April 3, 2009

Re: NOTICE OF SAFETY RECALL
Voluntary Recall of Models 3068 and 3069 Fit Kits

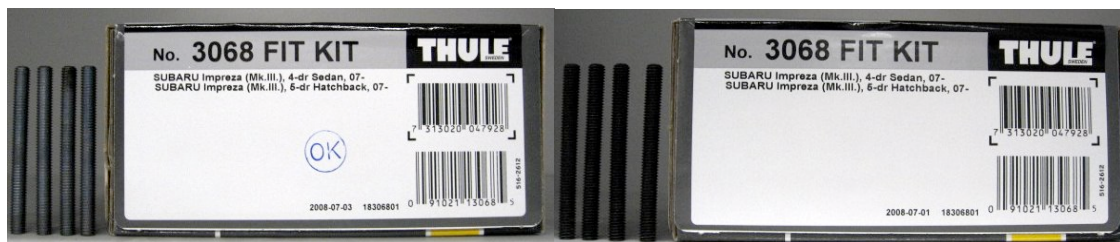
It has recently been determined that the bolt(s) used to secure the foot to the vehicle was manufactured to a hardness that may cause the bolt(s) to be brittle and potentially break under stress. This may result in the bolt(s) snapping off during use with or without a load. The unsecured rack and load can then come loose while driving creating a potential hazard to the consumer and/or others on the roadway.

GOOD (Silver-colored bolts and OK stamp)

NOT GOOD (Black-colored bolts and no stamp)

In order to remedy this situation, please call your Thule Dealer Services Representative at (800) 848-5322 to receive an RA # and Thule will issue you an exchange, refund or credit - whichever you prefer. Replacement kits are available and can be distinguished by their labeling (they are visibly marked with an "OK" label on the outside of the carton) as well as their respective hardware (the new bolts are silver-colored vs. the original bolts, which were black-colored).
